**STAFF RECOMMENDATION**

**942 Maxwell Avenue**

**February 19, 2020**

**Description of Project:** Application is to construction a rear addition that incorporates a ridge raise.

**LEFT ELEVATION**  
SCALE: 1/4"=1'-0"

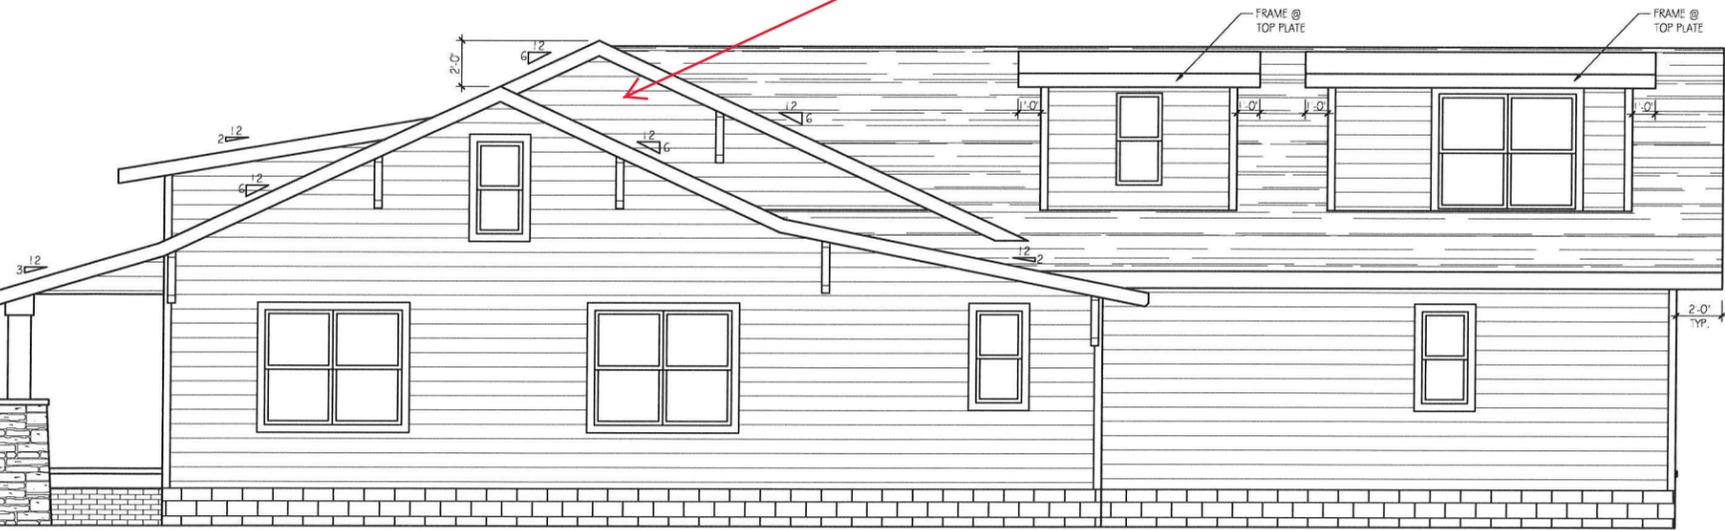
Per architect, side wall of ridge raise will line up with face of dormers on the addition.

**SECOND FLOOR PLAN**  
SCALE: 1/4"=1'-0"

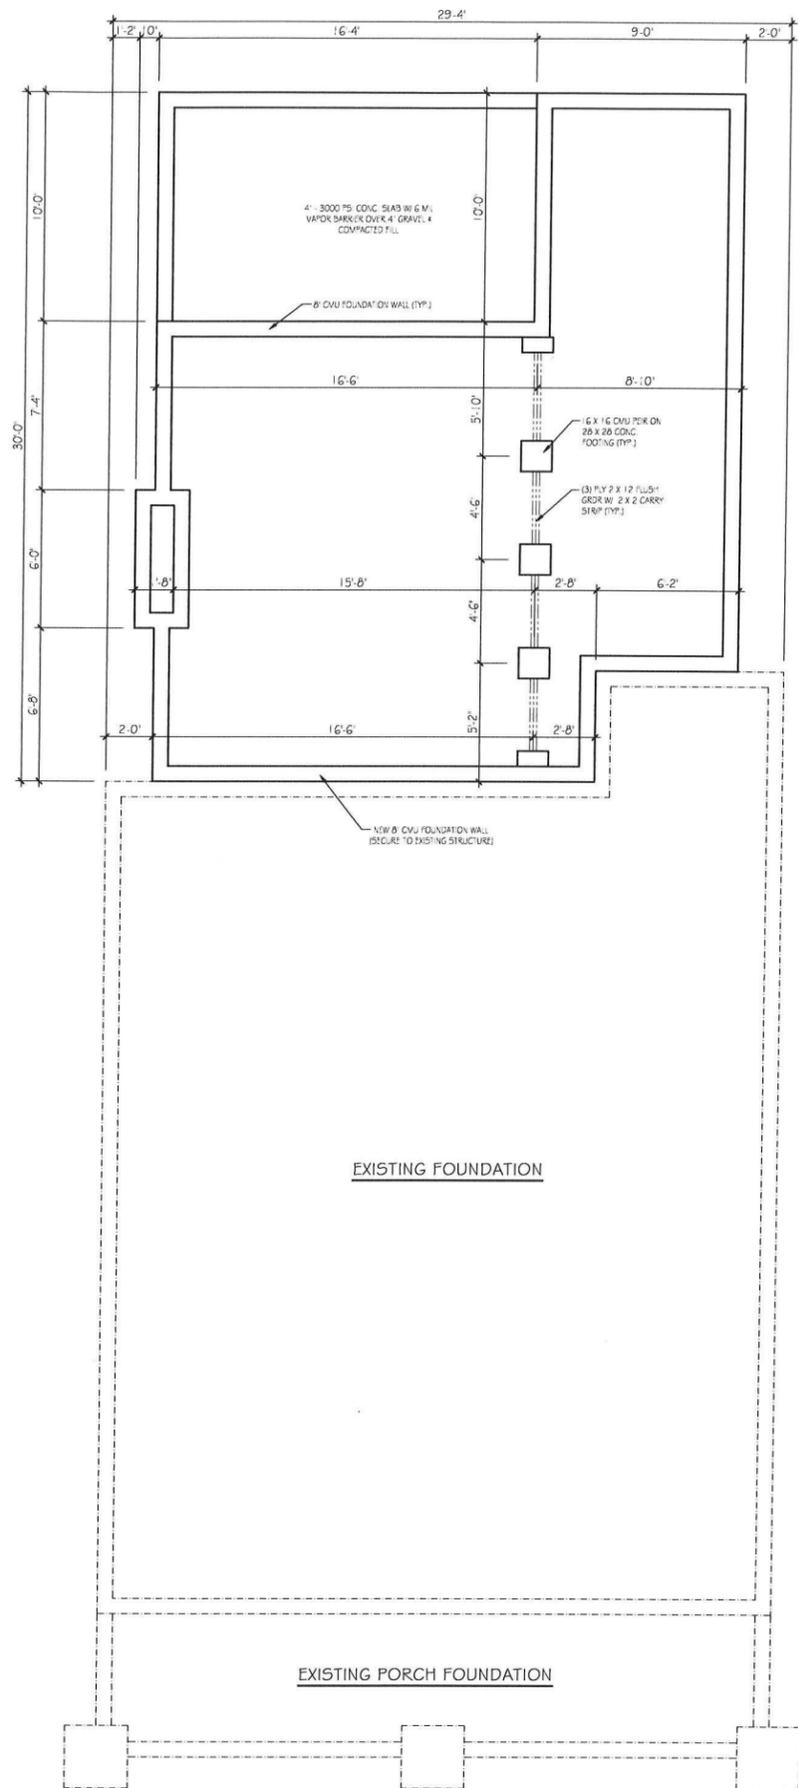
Per architect, side wall of ridge raise will line up with side wall of dormers on the addition.
